DEVELOPMENT APPLICATION ASSESSMENT REPORT

Application Number:	DA2024/1733
----------------------------	-------------

Responsible Officer:	Dean Pattalis
Land to be developed (Address):	Lot 8 DP 244469, 5 Roosevelt Avenue ALLAMBIE HEIGHTS NSW 2100
Proposed Development:	Alterations and additions to a dwelling house including a swimming pool
Zoning:	Warringah LEP2011 - Land zoned R2 Low Density Residential
Development Permissible:	Yes
Existing Use Rights:	No
Consent Authority:	Northern Beaches Council
Land and Environment Court Action:	No
Applicant:	Aaron John Hawkins

Figure 1: SW encroachment

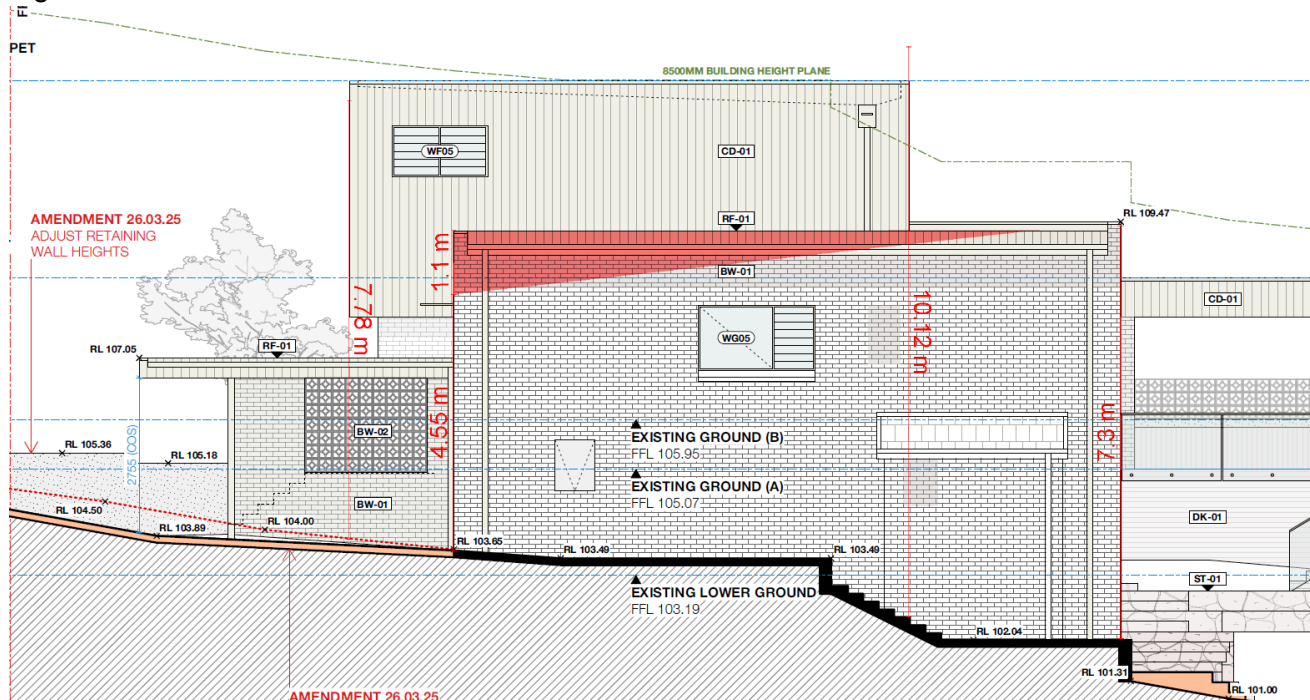
The proposed first floor encroaches the building envelope by a maximum of 1.1m on the south-west elevation and 1.23m on the north-east elevation.

It is noted the area of encroachment on the south-west elevation relates to an existing wall which is being increased slightly in height with no change to the existing setback. In relation to the north-eastern side, a minimum side setback of 2.23m is provided which is considered adequate to ensure only a minor resultant envelope breach. Generally minimal floor to ceiling height are also proposed.
